# STATION

— FAIRFAX, CALIFORNIA —

Response to Comments dated April 1, 2015

**Subject: Review of Preliminary Plans for Restaurant at 2001 Sir Francis Drake Boulevard**

**Residual Hydrocarbon Impact Areas**

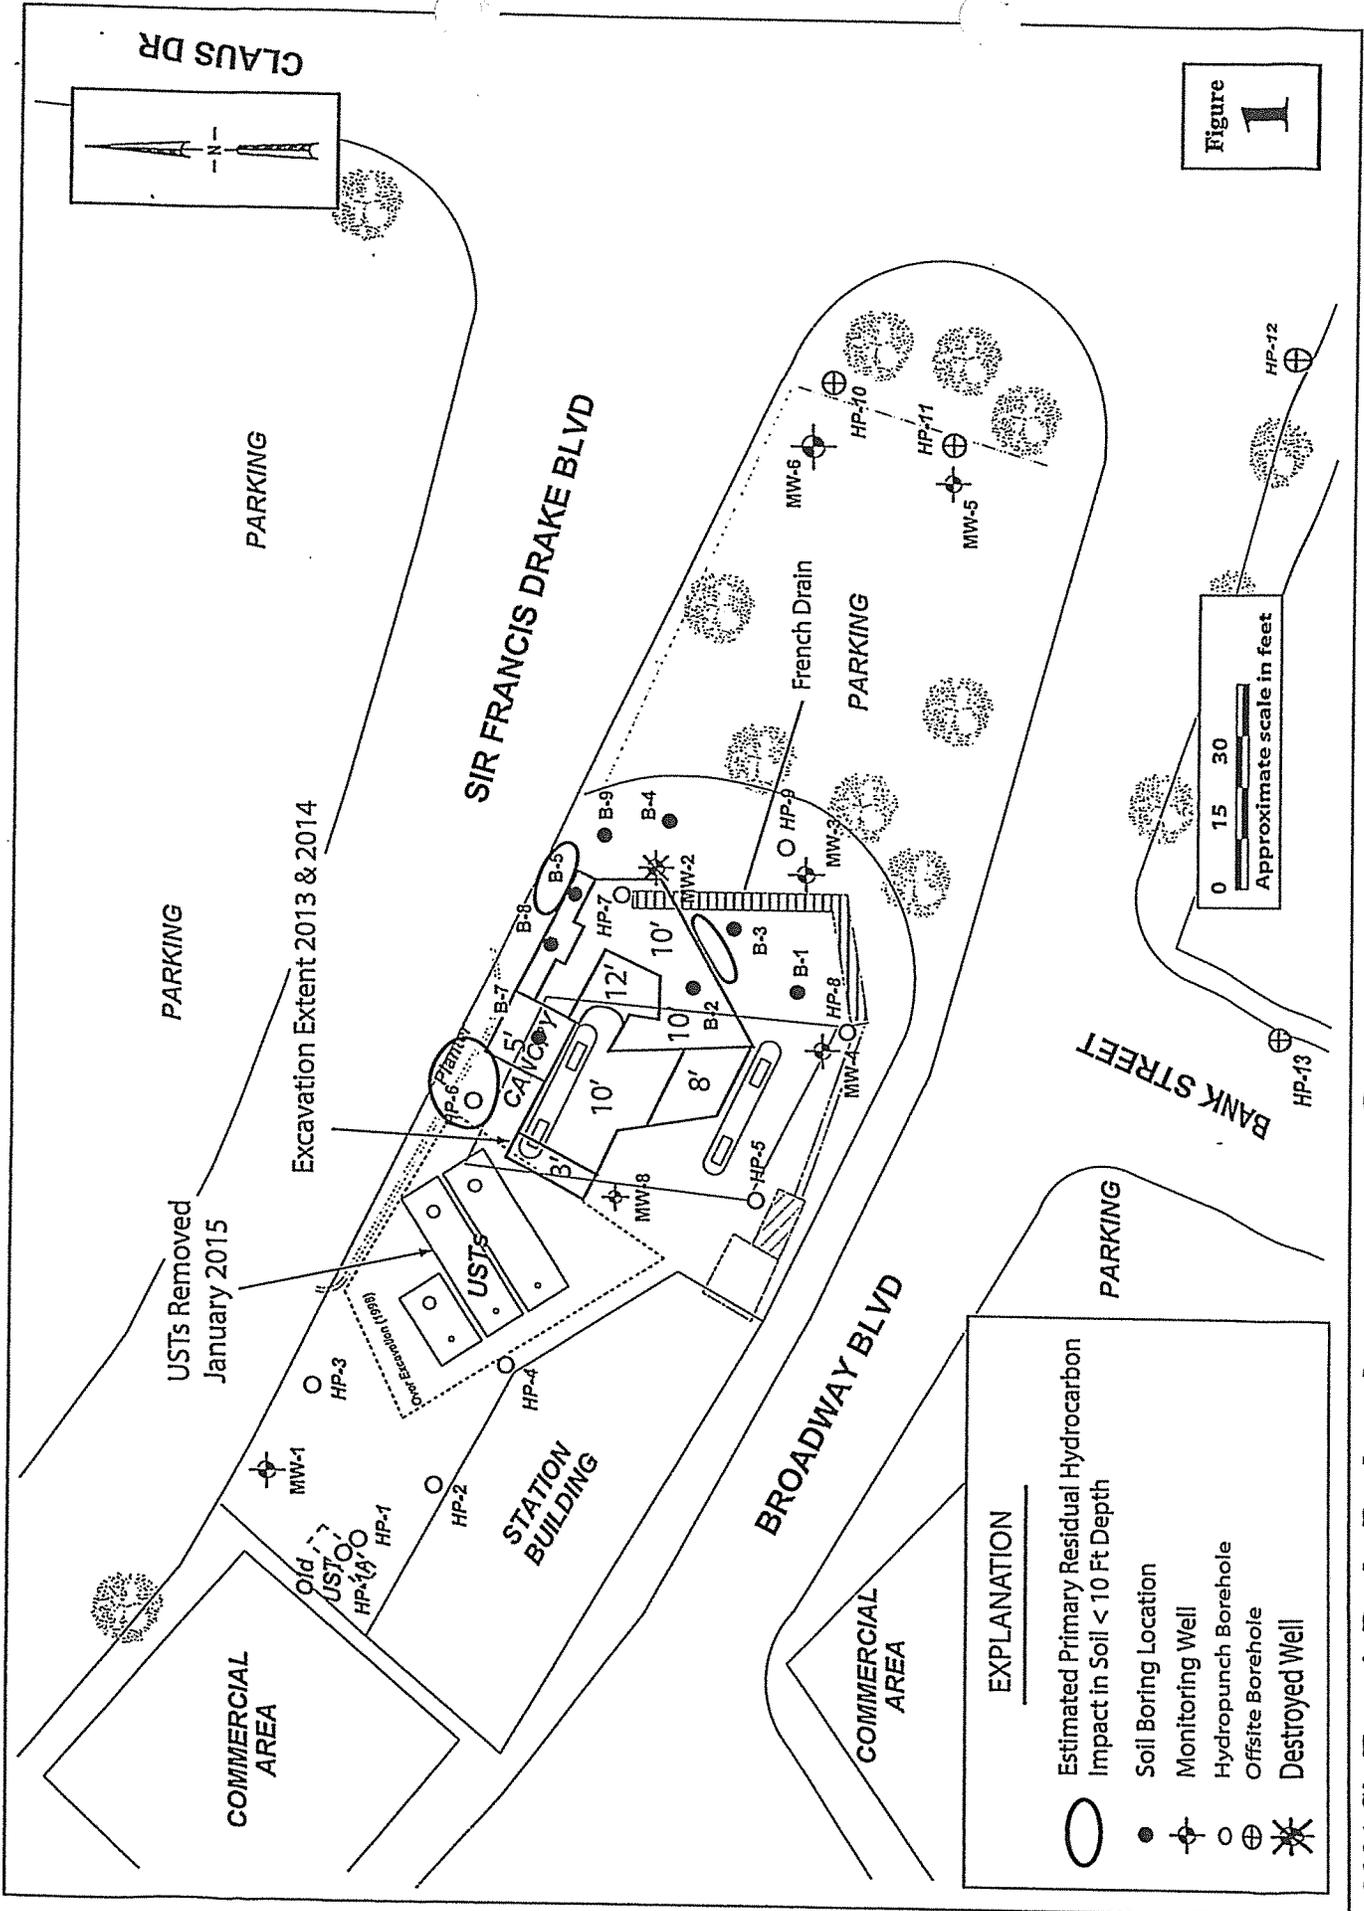
- All soil representing potential vapor intrusion per LTCP criteria has been removed for commercial site use. The extent of soil excavation is shown on Figure 1.

- Residual soil impact is primarily present adjacent 2001 Sir Francis Drake Boulevard, in deeper soil under the bottom of the former excavation, and at one limited area 5 ft depth at the southeastern boundary of the former excavation. This impact shown on Figure 1 is below LTCP criteria and does not merit further action. As shown on the planned development Figure A1.00, the residual impact is located in outdoor areas that will be covered with pavement. As shown on Figure A1.00, the impact is beneath the planned BBQ grill, bicycle rack, and planter.
